RE: **Addendum No. 1/City of Mission Event Center**
Request for Proposal No.: 17-010-11-29

ADDENDUM 1

Date: 11-16-2016
Project: Mission Event Center
Project No.: 2016-01

SHEET NO.
A-9
9 of 10

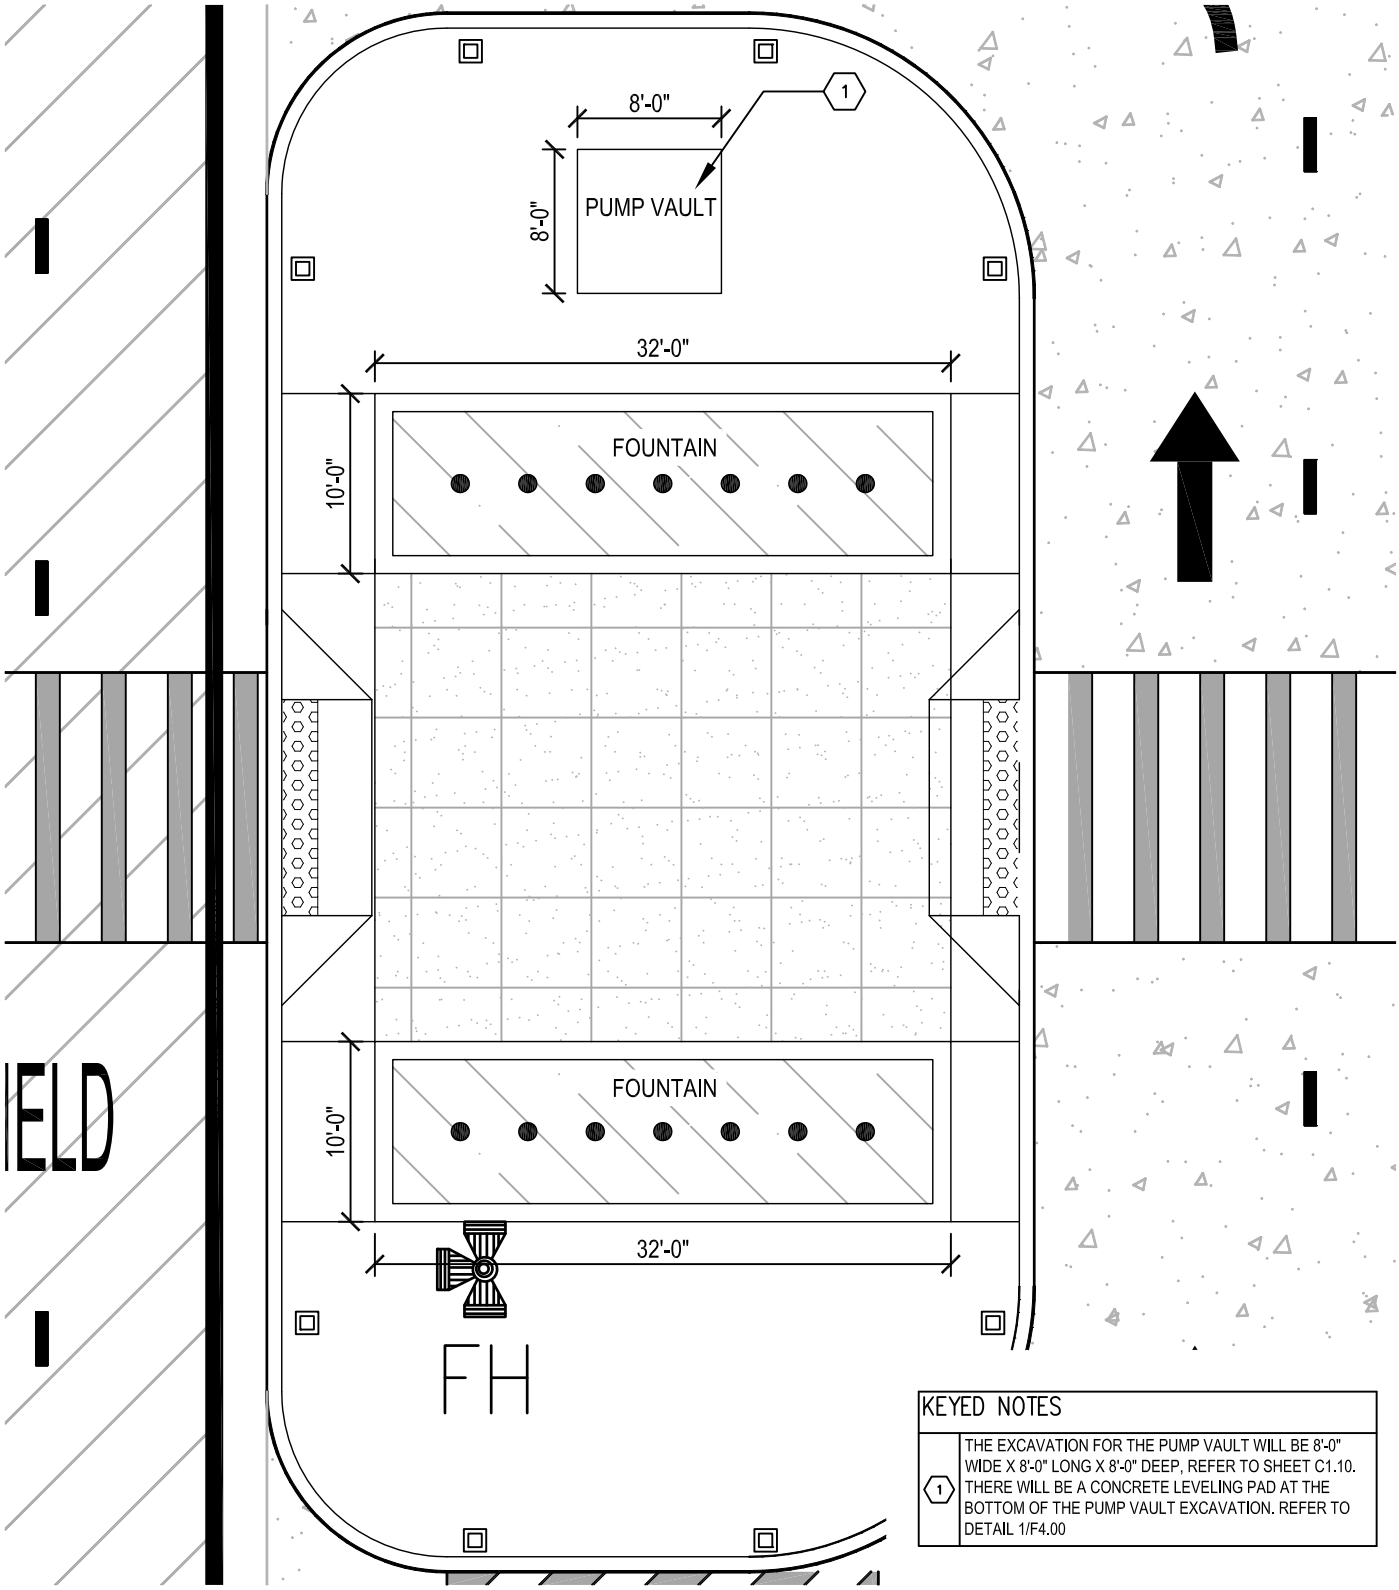
16. *Clarification:* The fountain dimensions are 10'-0" wide x 32'-0" long x 4'-0" deep. The pump vault dimensions are 8'-0" wide x 8'-0" long x 8'-0" deep. Refer to revised to **Sheet A-9**.

2. *Clarification:* C1.10. The excavation for the **pump vault** will be 8'-0" wide x 8'-0" long x 8'-0" deep. There will be a concrete leveling pad at the bottom of this excavation. Refer to detail 1/F4.00.

SHEET NO.
A10
10of10

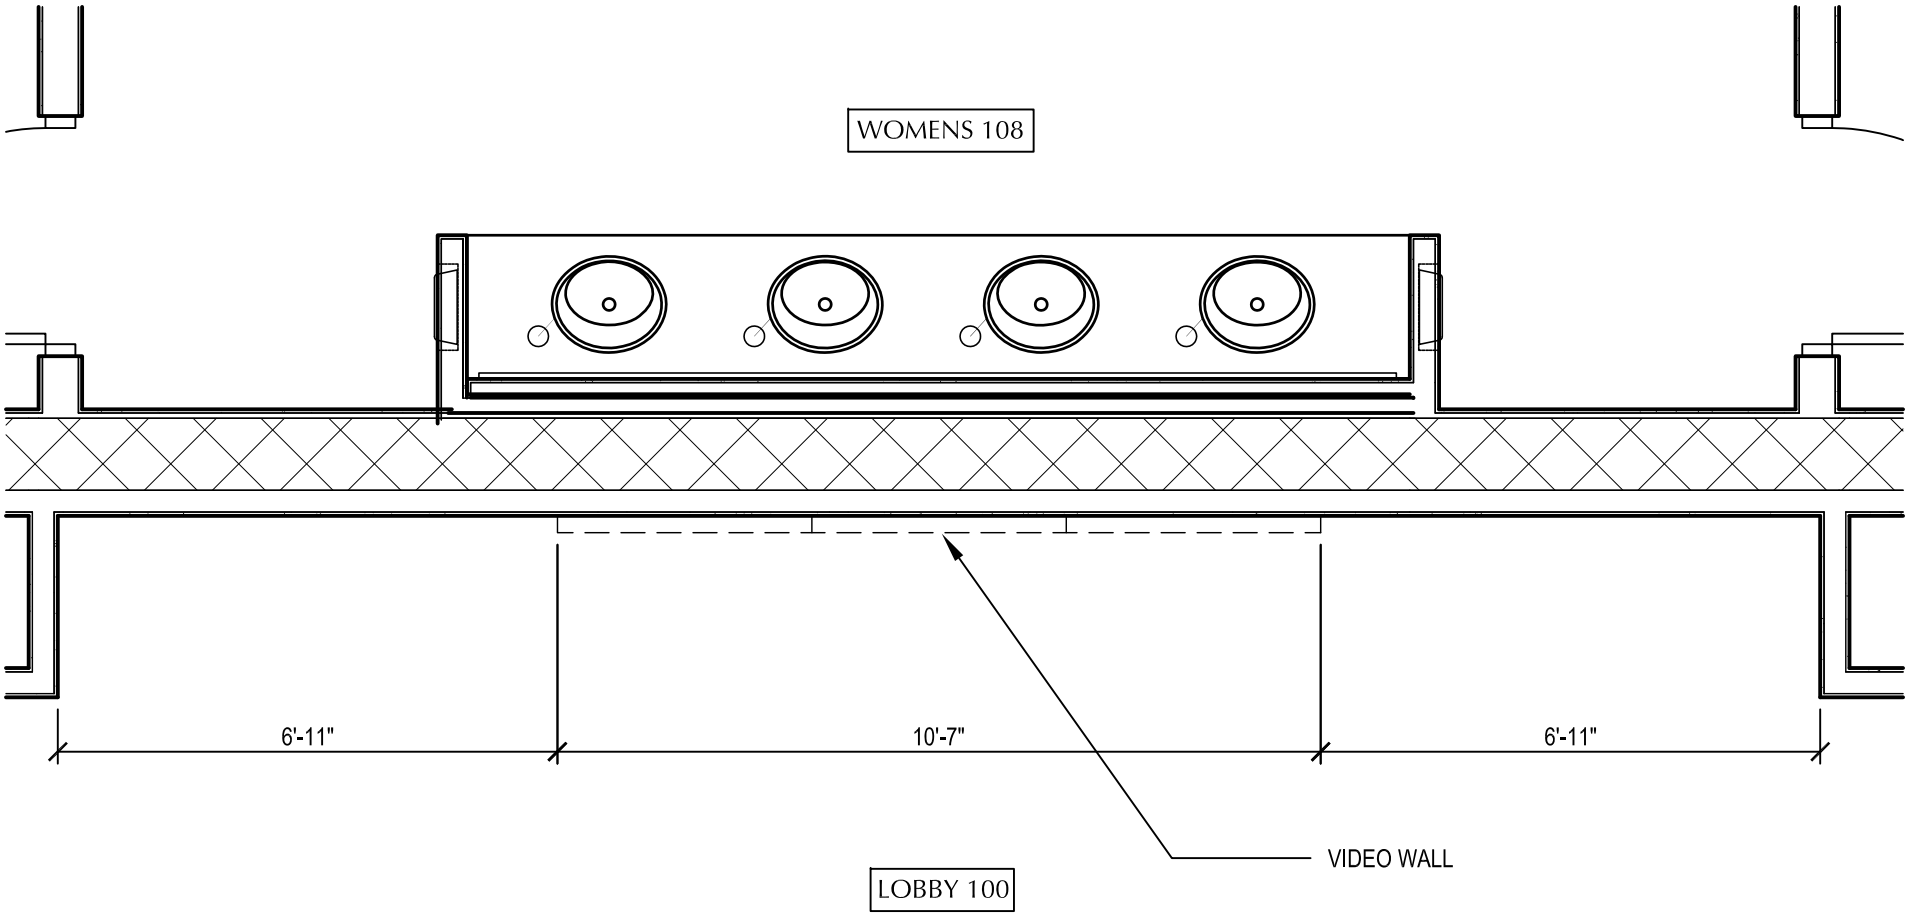
17. *Clarification:* For location of the Video Wall to be installed in the lobby please refer to **Sheet A-10** attached herewith. Refer to **Sheets A4.05, E1.2 & AV1.0** for additional clarifications**.** Provide electrical, data & blocking as required

SHEET NO
A1.01

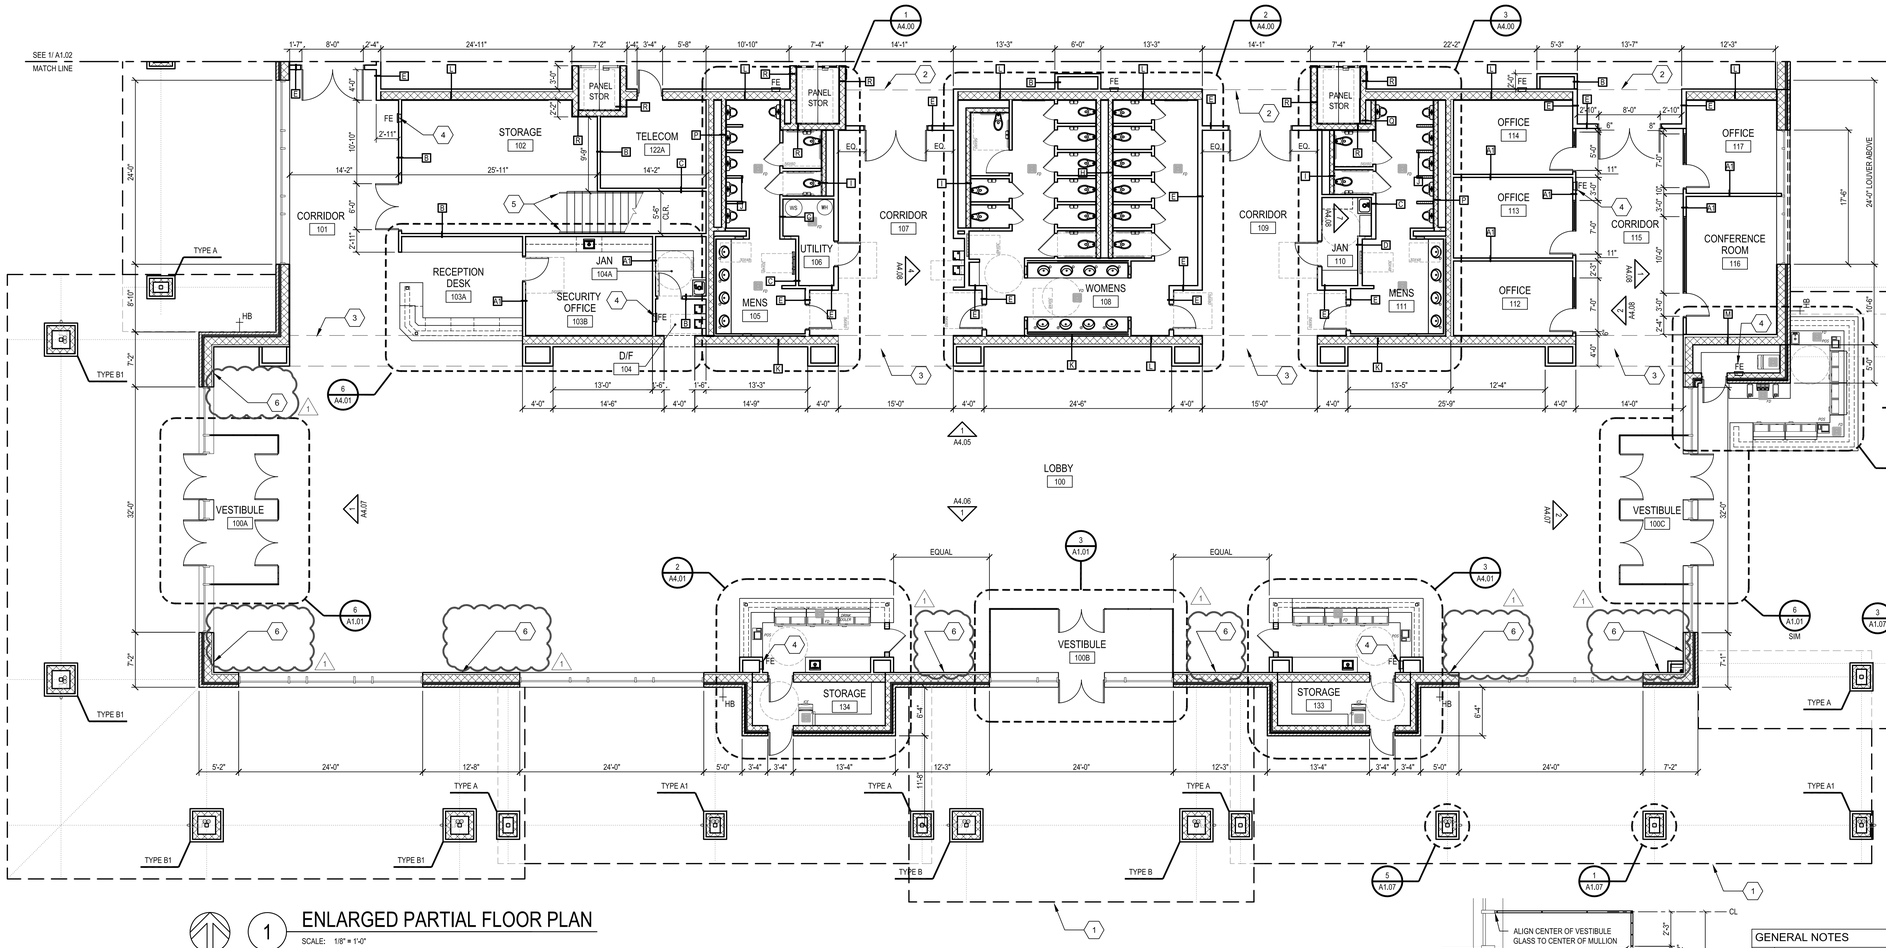
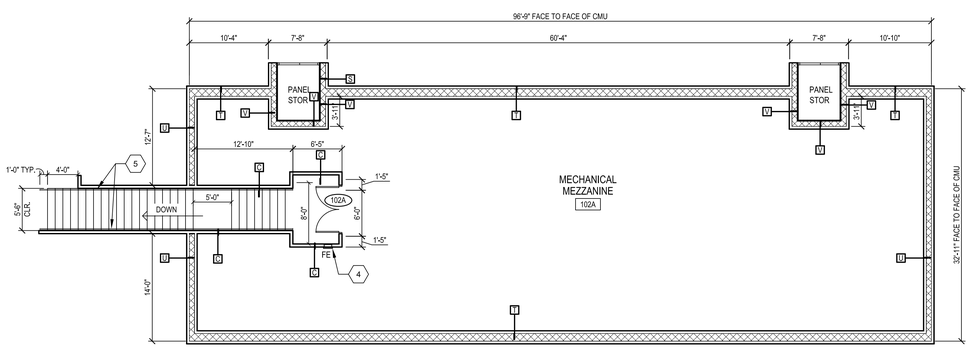
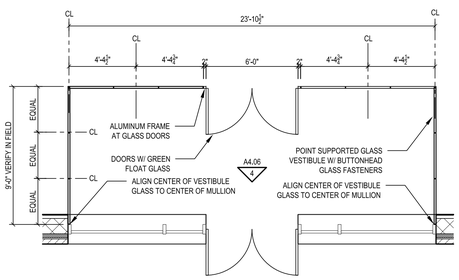
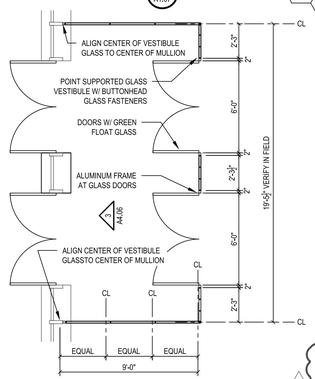
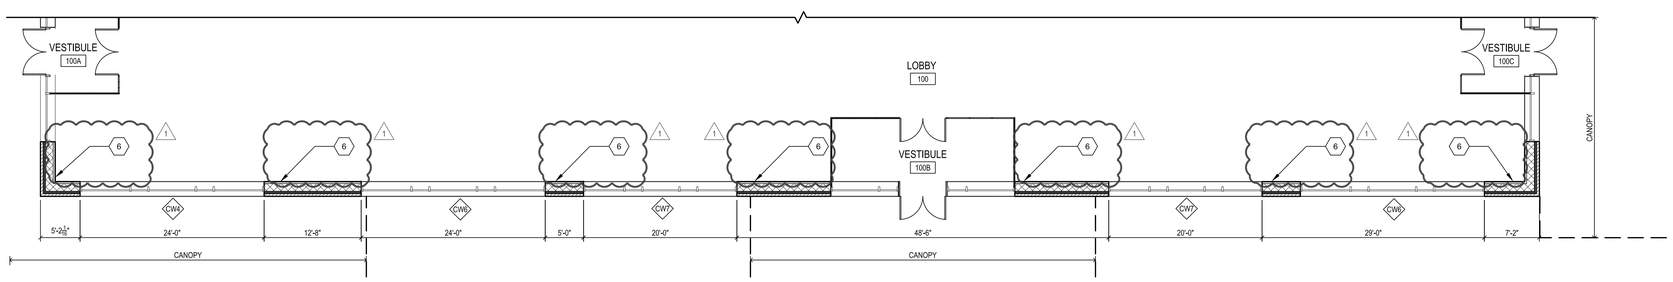
8. *Modification:* Contractor to provide and install 1-1/2" (25ga) Furring Channels in lieu of 7/8" Furring Channels originally called for; throughout the entire project. Refer to revised **Sheet A1.01 & A1.02** attached herewith.

SHEET NO
A1.02

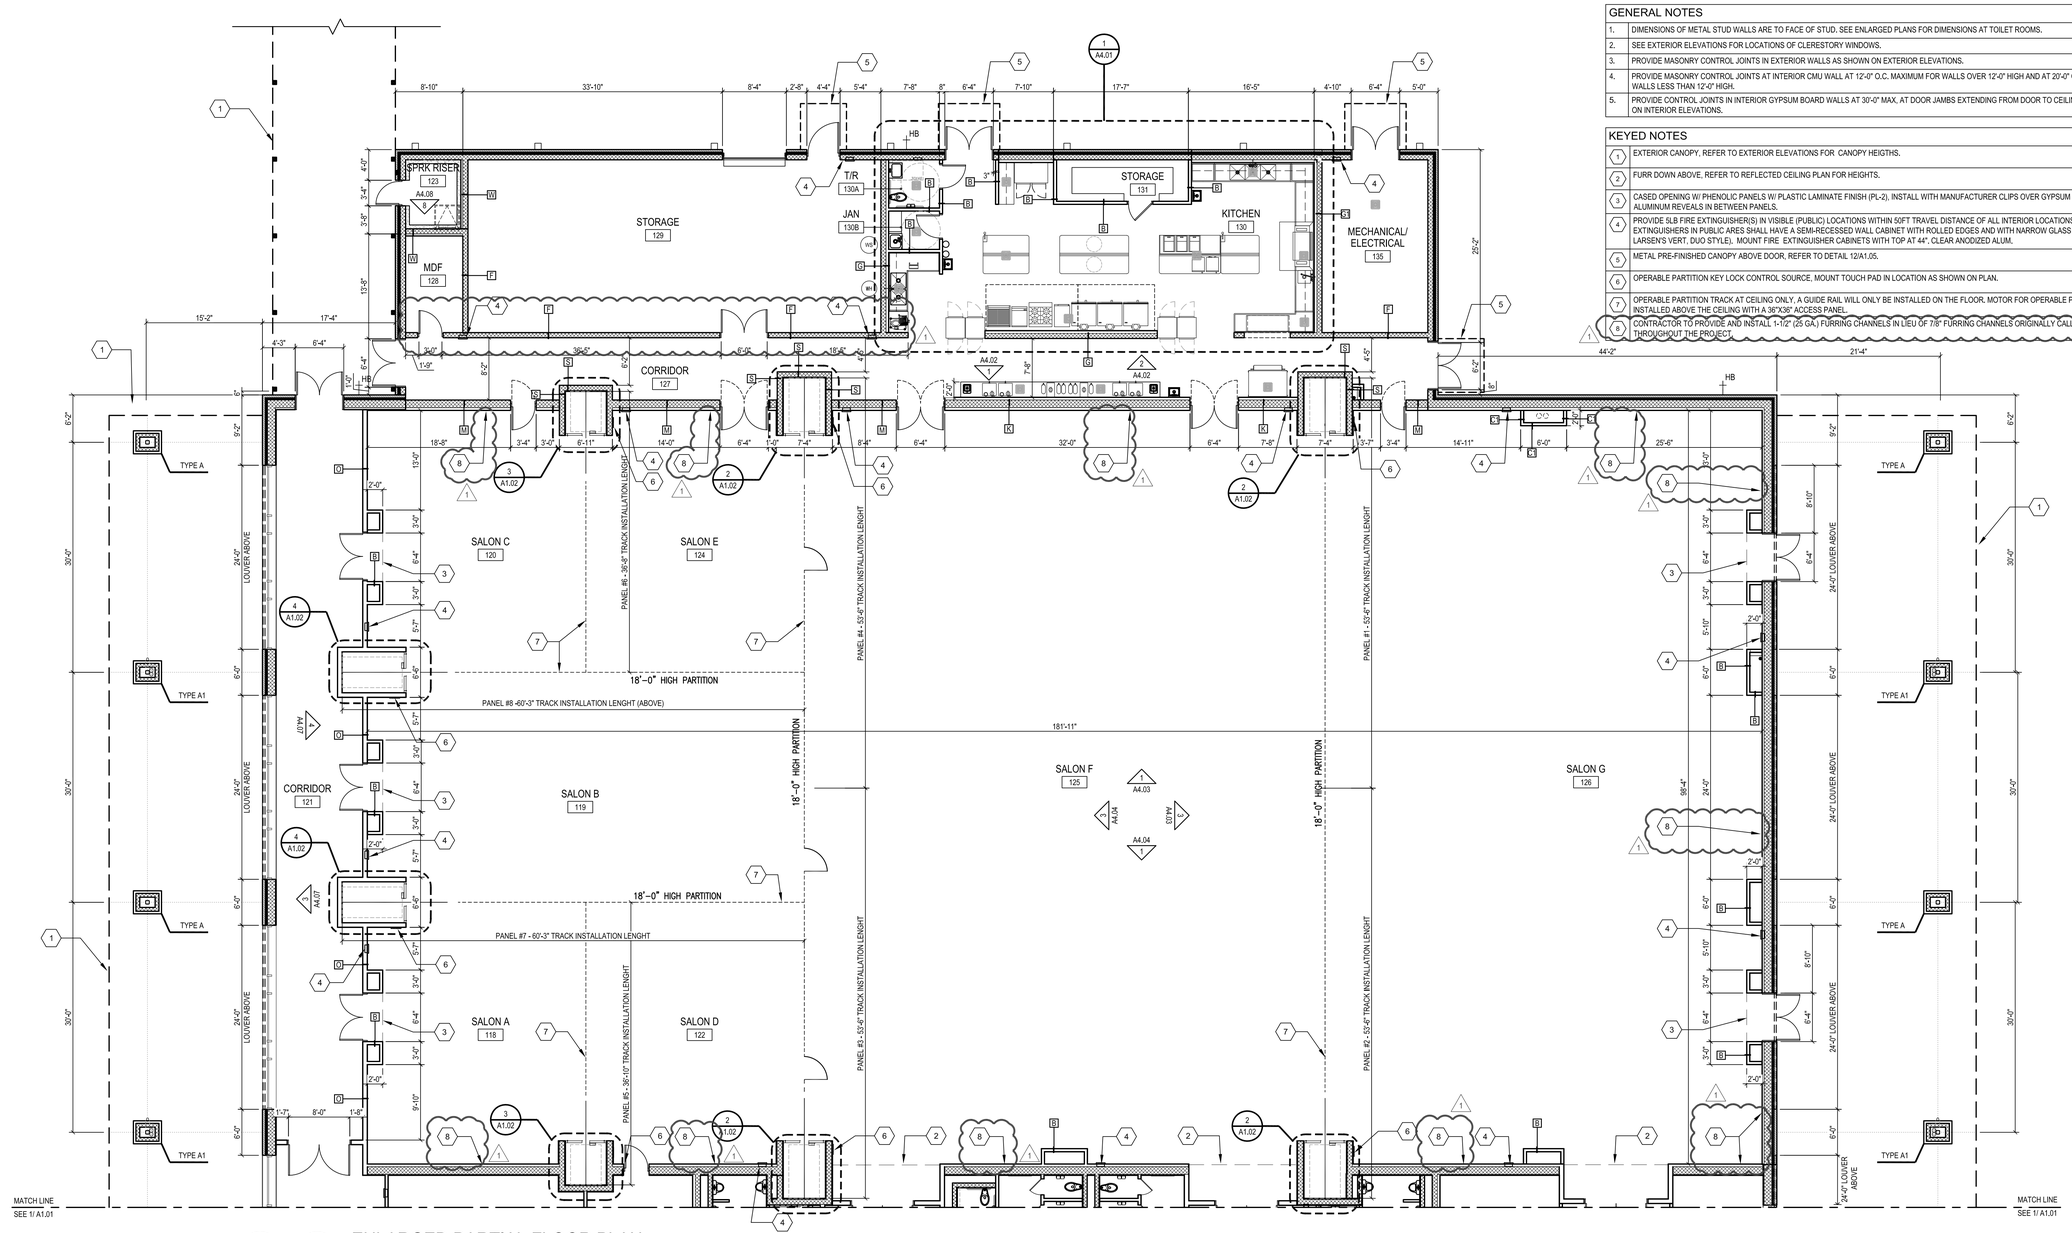
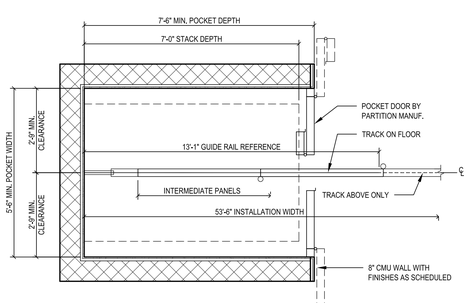
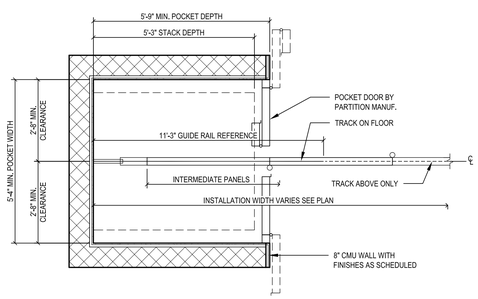
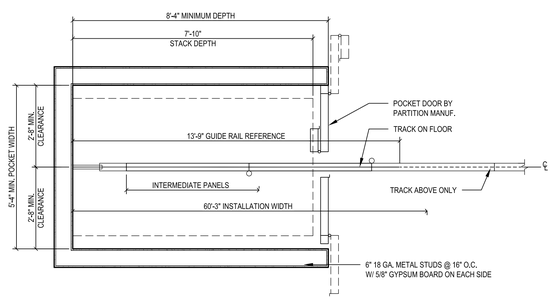
19. *Clarification:* Wall between Corridor 127 and Storage 129 shall be constructed with 8" CMU; Wall Type F. Refer to **2/A4.02** and revised **Sheet A1.02.**
